## VILLAGE REVIEW BOARD AGENDA COUNCIL CHAMBERS, 85 UNION STREET WEDNESDAY, FEBRUARY 3<sup>RD</sup>, 5:00 PM

1. **Case # VRB 16-001 – 15 Jordan Avenue** – The Board will discuss and take action regarding a Certificate of Appropriateness for the demolition of a portion of an existing commercial structure and construction of replacement structure at 15 Jordan Avenue (Map U08, Lot 41).
2. **Pre-Application Consultation – 9 Cleaveland Street** - The Board will discuss and provide guidance to applicant, First Parish Church Brunswick, regarding proposed renovations to Pilgrim House at 9 Cleaveland Street (Map U08, Lot 112).
3. **Other Business**
4. **Approval of Minutes**
5. **Next Meeting Date**

**Draft Findings of Fact  
15 Jordan Avenue  
Request for Two Certificates of Appropriateness for Demolition and New Construction  
Village Review Board  
Review Date: February 3, 2016**

**DRAFT MOTIONS  
15 JORDAN AVENUE  
REQUEST FOR TWO CERTIFICATES OF APPROPRIATENESS FOR DEMOLITION  
AND NEW CONSTRUCTION  
VILLAGE REVIEW BOARD  
REVIEW DATE: FEBRUARY 3, 2016**

SIDE & REAR VIEW Looking from STREET		
SCALE: 1" = 5'	APPROVED BY:	DRAWN BY LKO J.
DATE: 01/03/16		REVISED

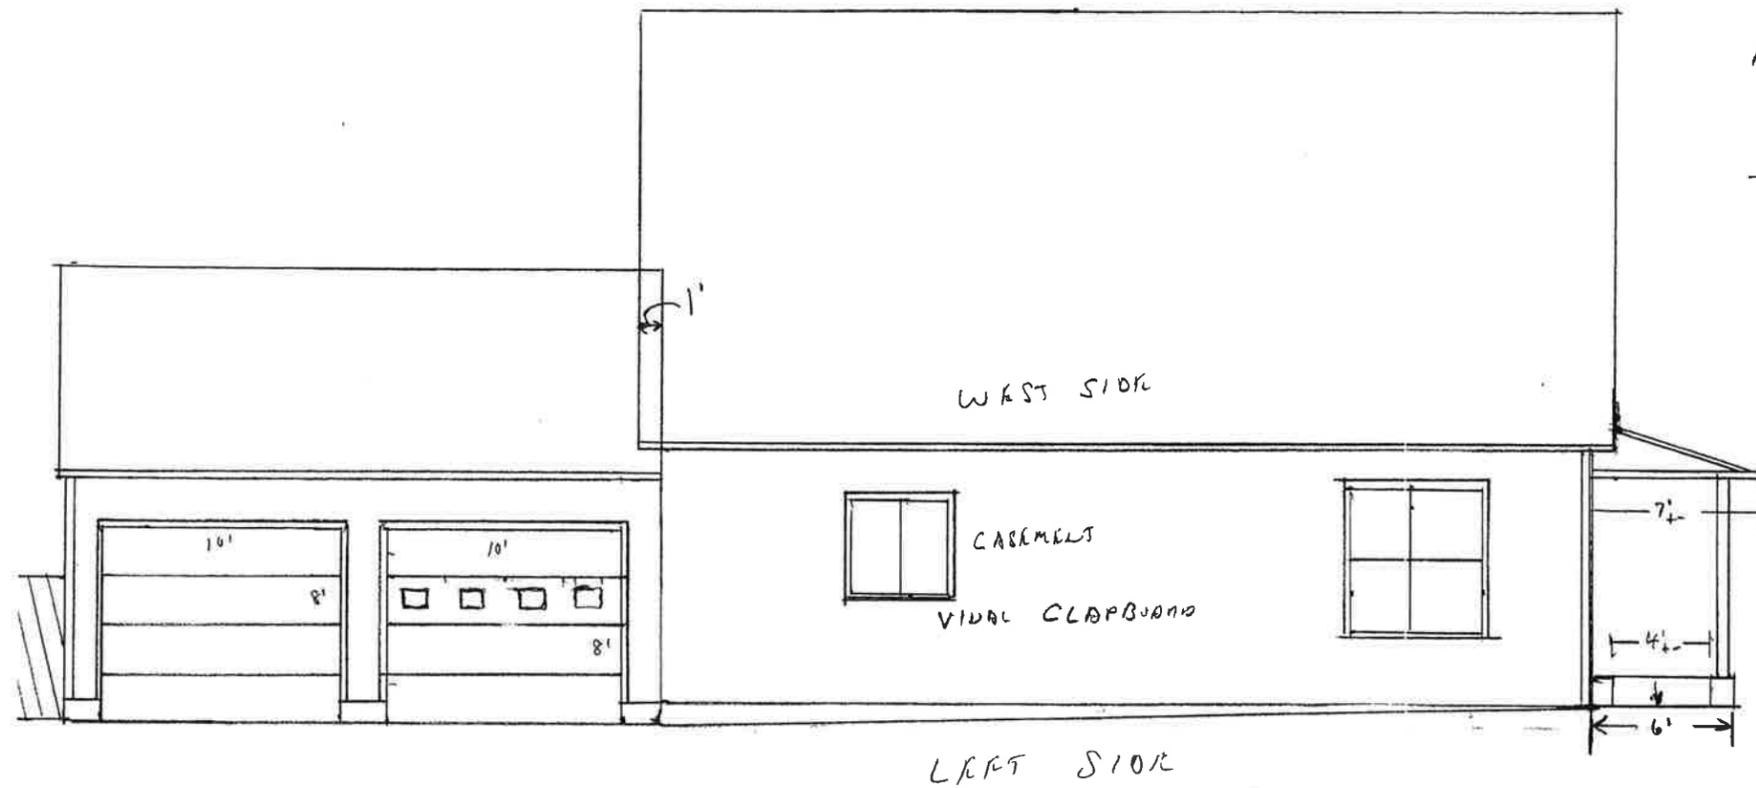
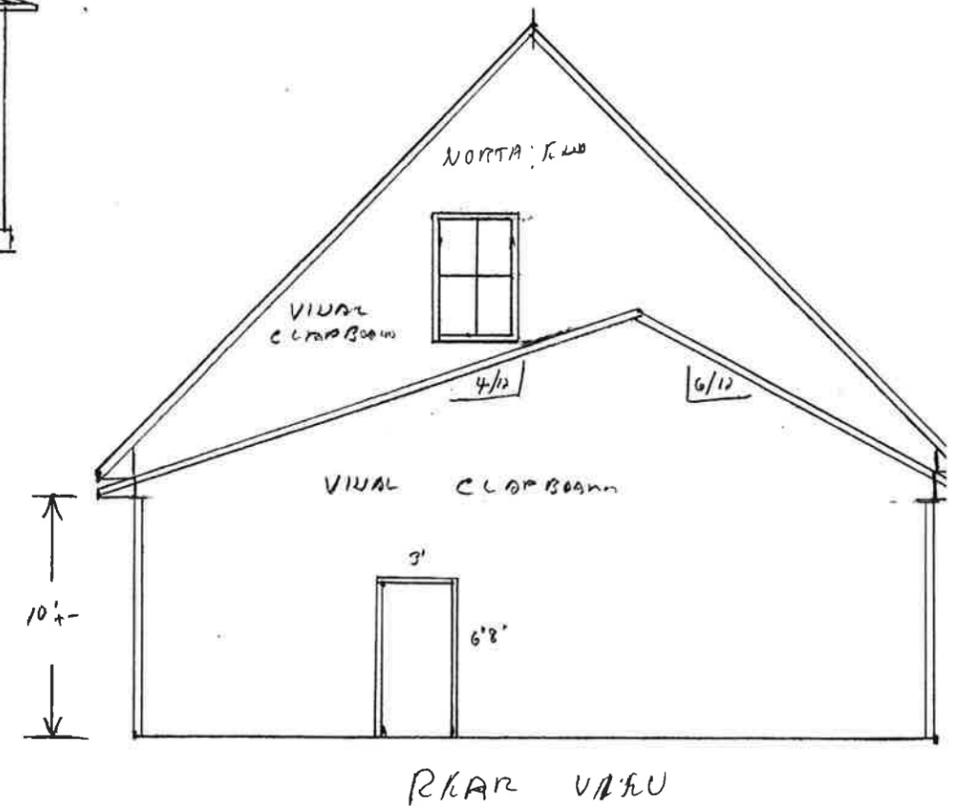
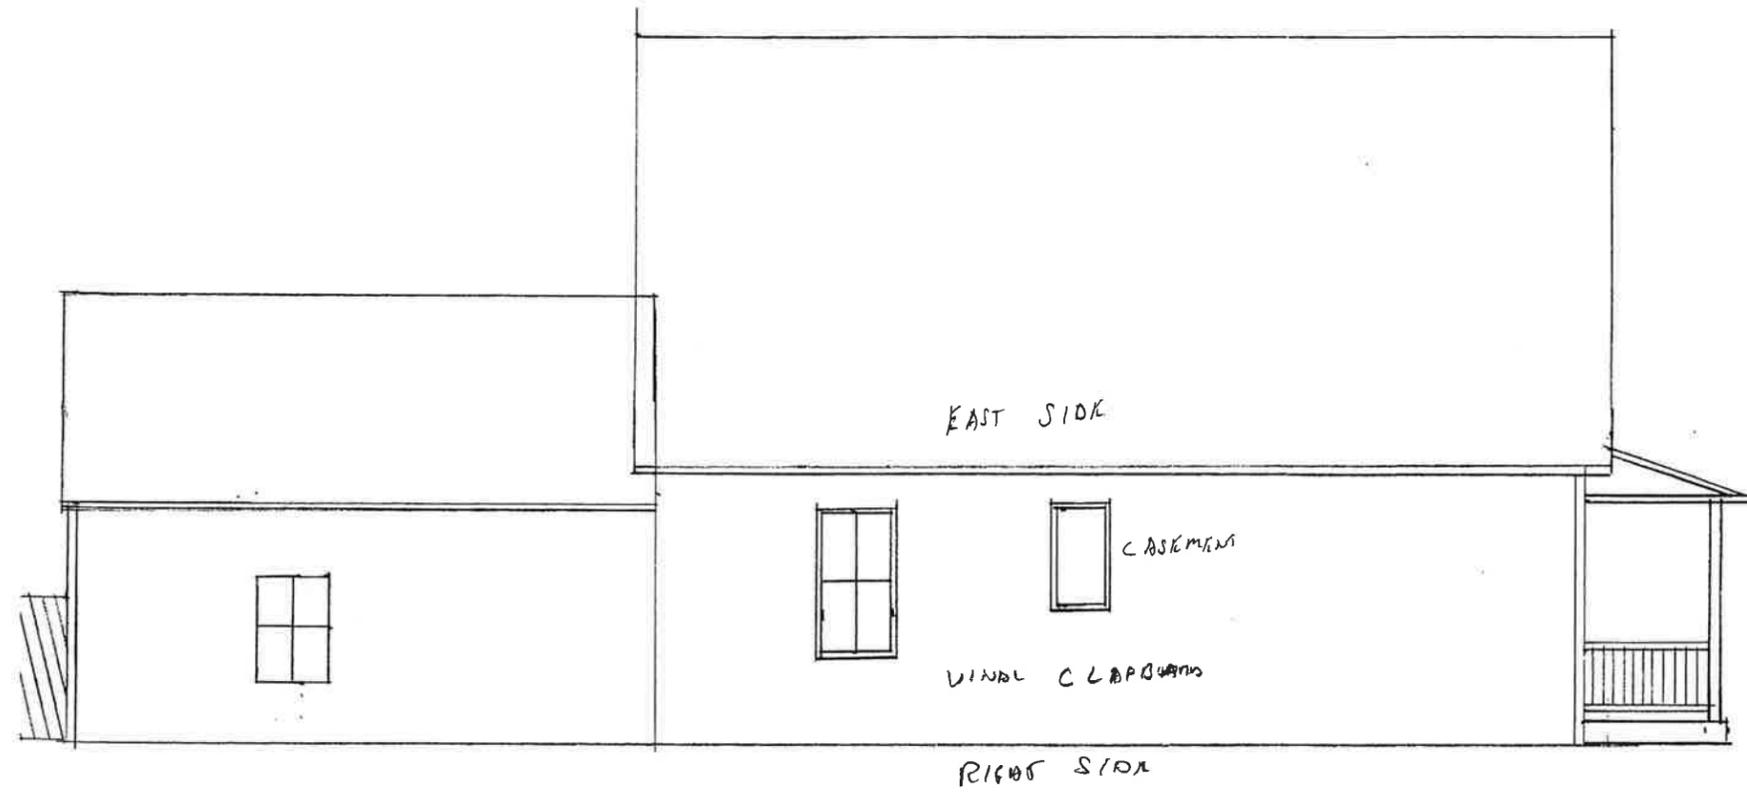
- d. New construction or additions shall be visually compatible with existing mass, scale and materials of the surrounding contributing resources.**  
*The proposed building design and its design elements are visually compatible with the existing mass, scale and materials of the surrounding resources. It provides for traditional design elements found along Jordan Avenue and will now match the average setback to the street. An 11-space side parking lot will be provided with planting beds placed on either side of the entrance. This entrance will also provide access to the attached 2-car garage to the rear of the building. Primary building materials include vinyl or clapboard siding, windows with grilles on top glass pane, and architectural shingles. Generally, building materials, overall design, height and setbacks are consistent in style with adjacent structures along Jordan Avenue within the Village Review Zone. It is recommended that simulated divided lights be used for window grilles and, if economically feasible, wood clapboard is preferred over vinyl siding.*

- b. **The use of vinyl, aluminum or other non-wood siding is permitted as illustrated in the Village Review Board Design Guidelines. Asphalt and asbestos siding are prohibited.** *Primary building material may be vinyl or clapboard. Wood clapboard is preferred.*

1. That the Board's review and approval does hereby refer to these findings of fact, the plans and materials submitted by the applicant and the written and oral comments of the applicant, his representatives, reviewing officials, and members of the public as reflected in the public record. Any changes to the approved plan not called for in these conditions of approval or otherwise approved by the Director of Planning and Development as a minor modification, shall require further review and approval in accordance with the Brunswick Zoning Ordinance.
2. That any mechanical equipment and dumpsters be located to the rear of the property with adequate screening to be determined during development review.

SITE PLAN		
SCALE: 1" = 10'	APPROVED BY:	DRAWN BY:
DATE: 03/25/15		REVISED:
		DRAWING NO:
		1

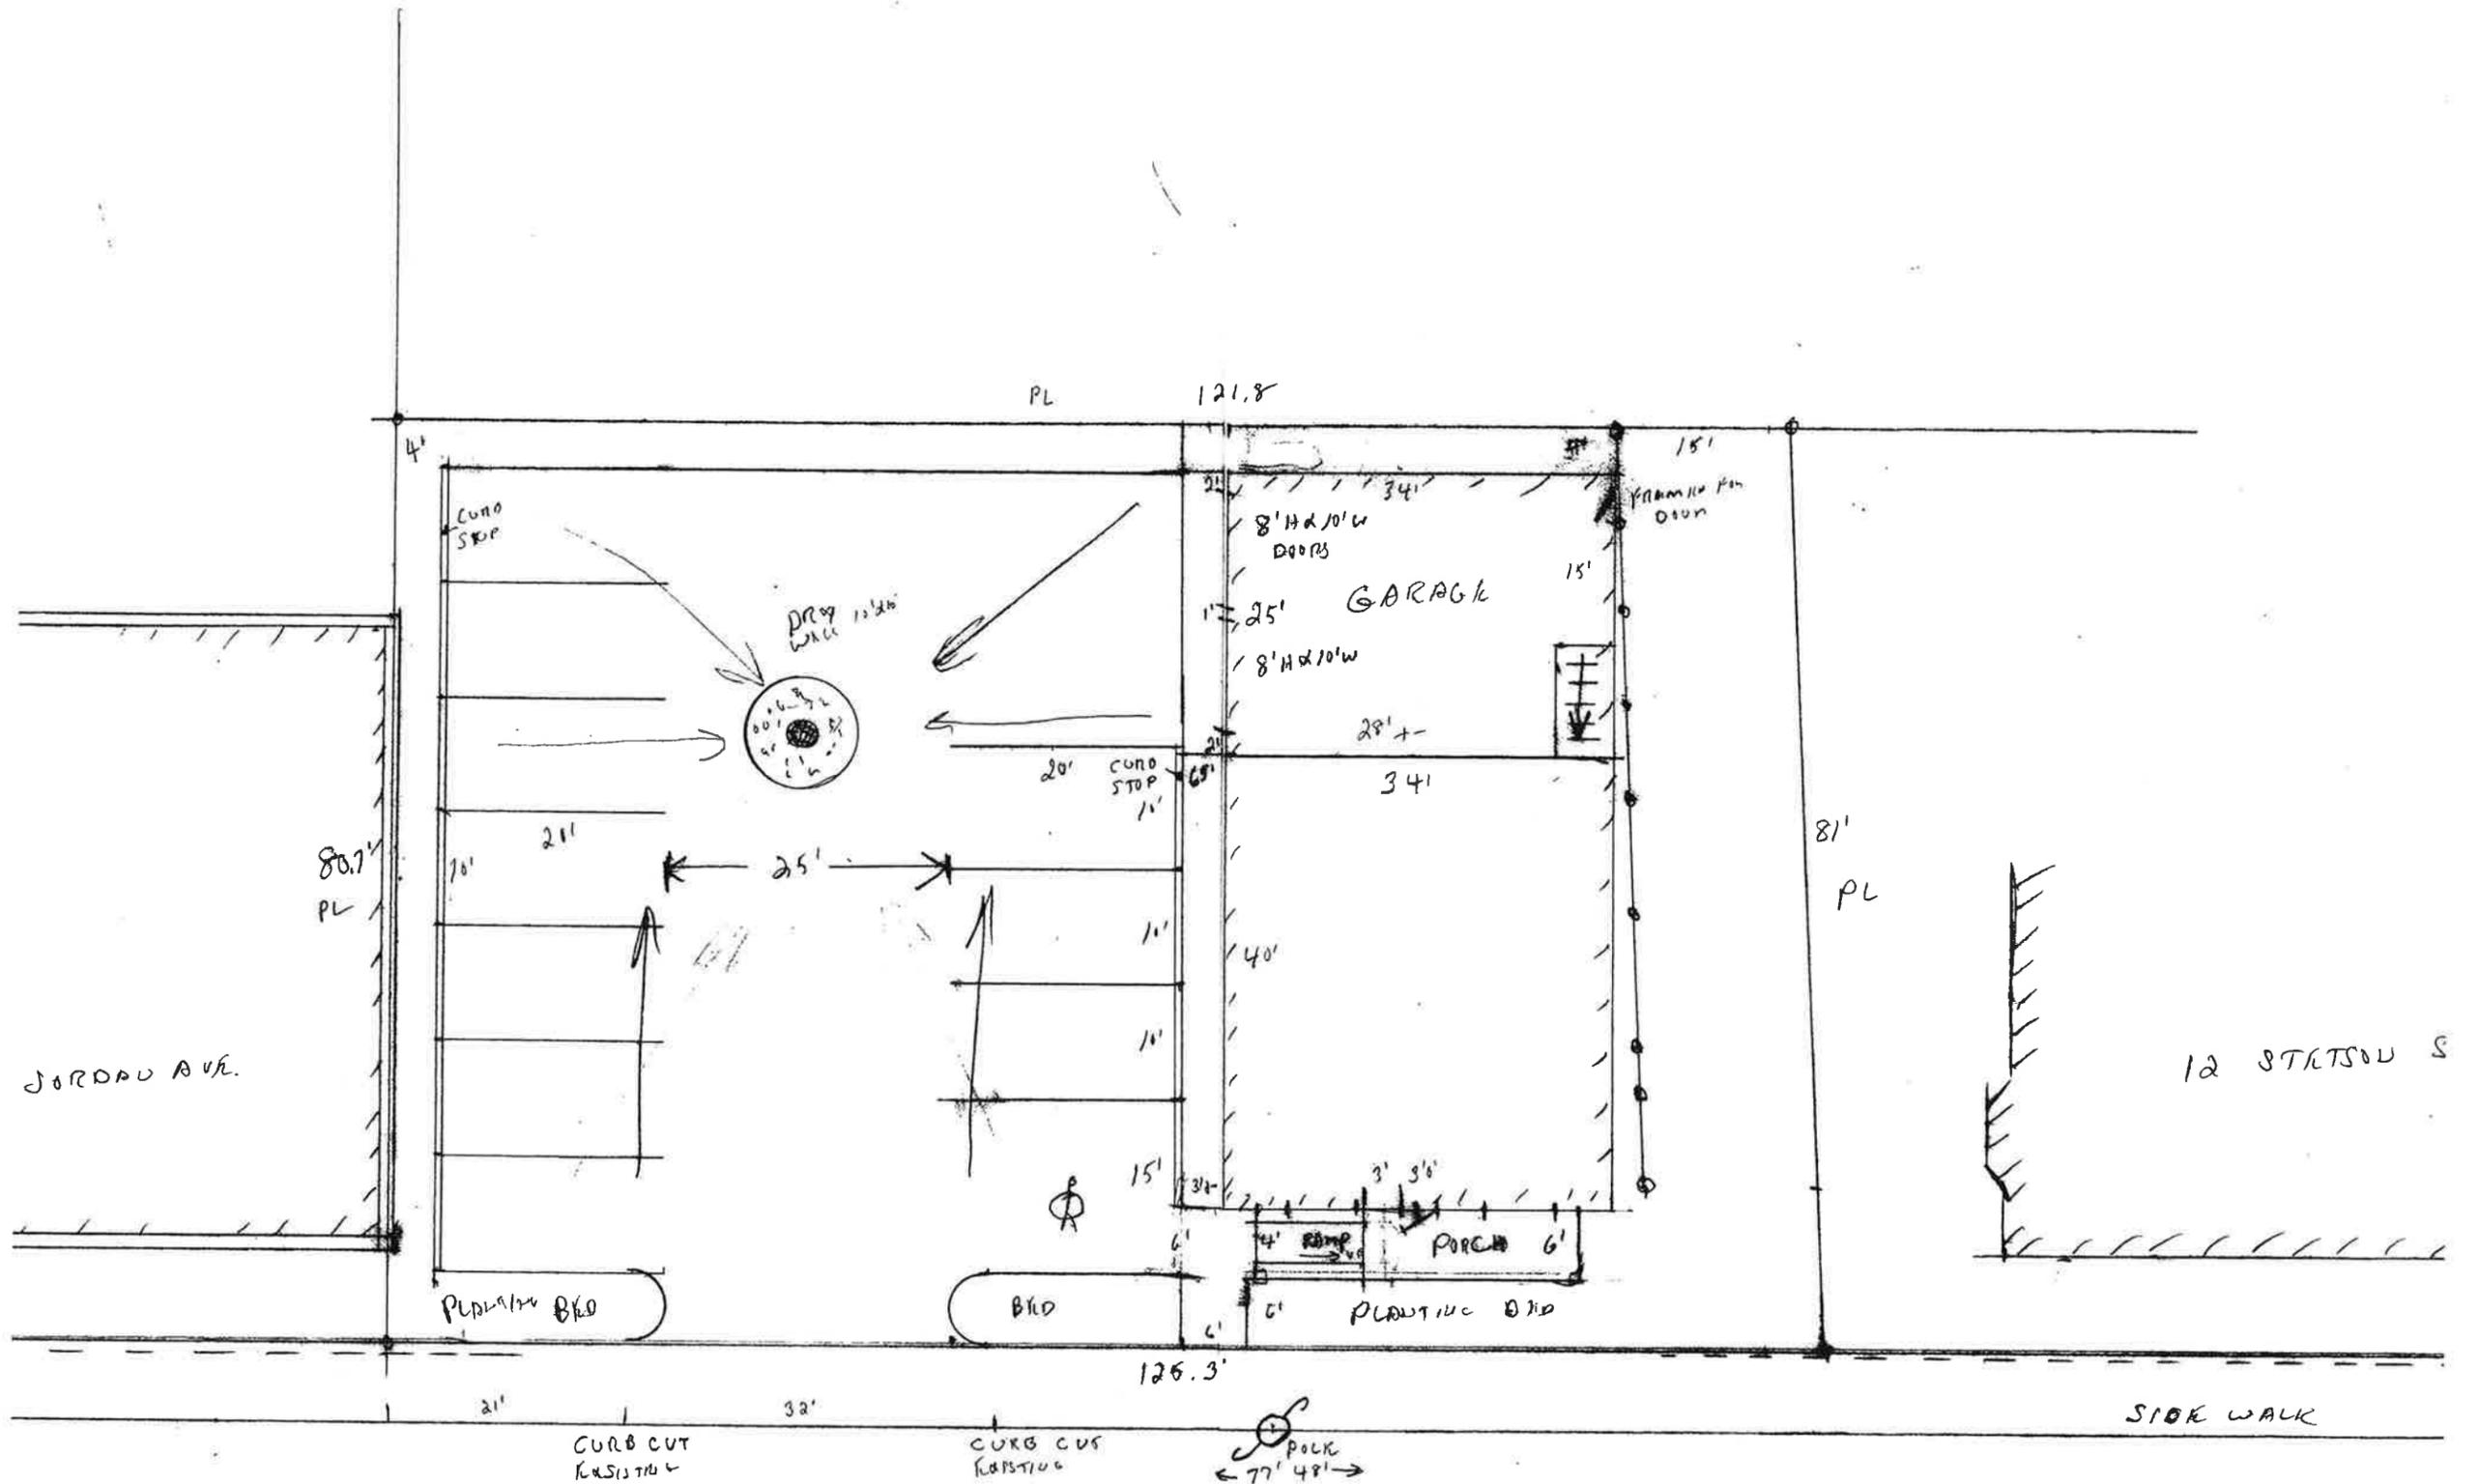
- 1) Parking lots shall be prohibited in side and front yards, except if the application involves the renovation of existing structures where such a configuration currently exists. In cases where such parking configurations exist, the parking area shall be screened from the public right-of-way with landscaping or fencing.** *Currently, a large non-landscaped parking lot is located at the site of the former 80 foot portion of the greenhouse, approved for demolition by the VRB in 1997. In addition a double width driveway now fronts the flower shop. The applicant is proposing to locate the new building at a 6 foot setback from the sidewalk, with the parking lot to the left of the building. Planting*

*beds of approximately 6 feet in depth will be located between the parking lot and sidewalk, on either side of the parking lot and should contain plantings to provide a suitable buffer between the parking lot and sidewalk.*

2. **Site plans shall identify pedestrian ways and connections from parking areas to public rights-of-way.** *As shown on the site plan, a pedestrian connection is provided to the sidewalk and the flower shop from the proposed parking lot.*

3. **All dumpsters and mechanical equipment shall be located no less than 25 feet away from a public right-of-way and shall be screened from public view.** *It is unknown at this time whether dumpsters will be used on site and will be determined as part of site plan review. Should dumpsters be located on site, the location shall be enclosed with a screened material, such as stockade fencing, to the rear of the property. Any ground mounted mechanical equipment should be located adjacent to the rear side wall or back wall of the structure.*

*A landscaping plan will be required as part of the site plan review submittal. Adequacy of parking will also be determined at that time.*
